March 2026

Brisbane City Council

Proposed Section 81 Application Changes to approved Church Building 163 Park Rd Woolloongabba

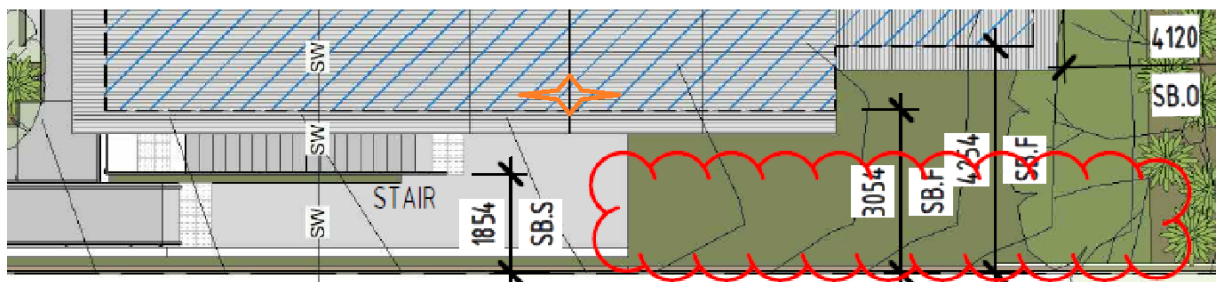
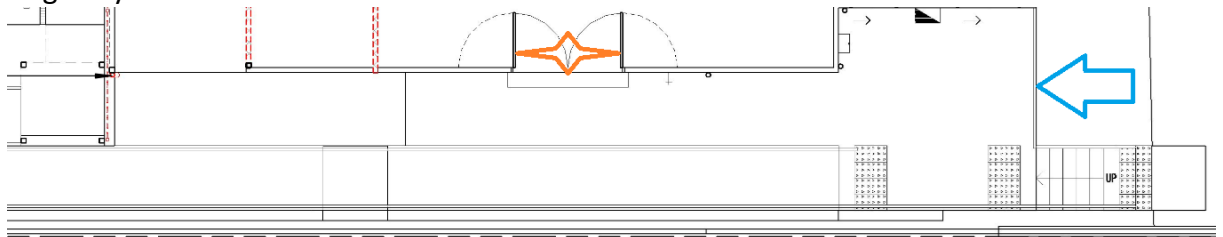
1. Problems with cladding. The cladding of the existing building is actually not original. It is an aluminium/foam sandwich cladding product applied post 1946 (see below).

The cladding cannot be replicated on the lower floor because the fire engineer has advised it doesn't meet the non flammable materials requirements for class 9b buildings.

The existing cladding has to be removed, and the new cladding on the ground floor has to be non flammable. A 150 mm Hardiplank product was selected to counter the class 9b non flammable materials issue.

The exterior wall finish located beneath the aluminium/foam cladding is weatherboard. The weatherboards exposed thus far appear to be significantly damaged by dry rot and significant sections of the boards will need to be replaced, especially on the eastern side. The damage is considered extensive enough that all the weatherboards need to be replaced, and the fire engineer has specified that the replacement material must be non flammable as per the ground level cladding.

Requested changes: the plans are altered to reflect the requested change. Condition 6 needs to be altered to allow removal of the vinyl cladding
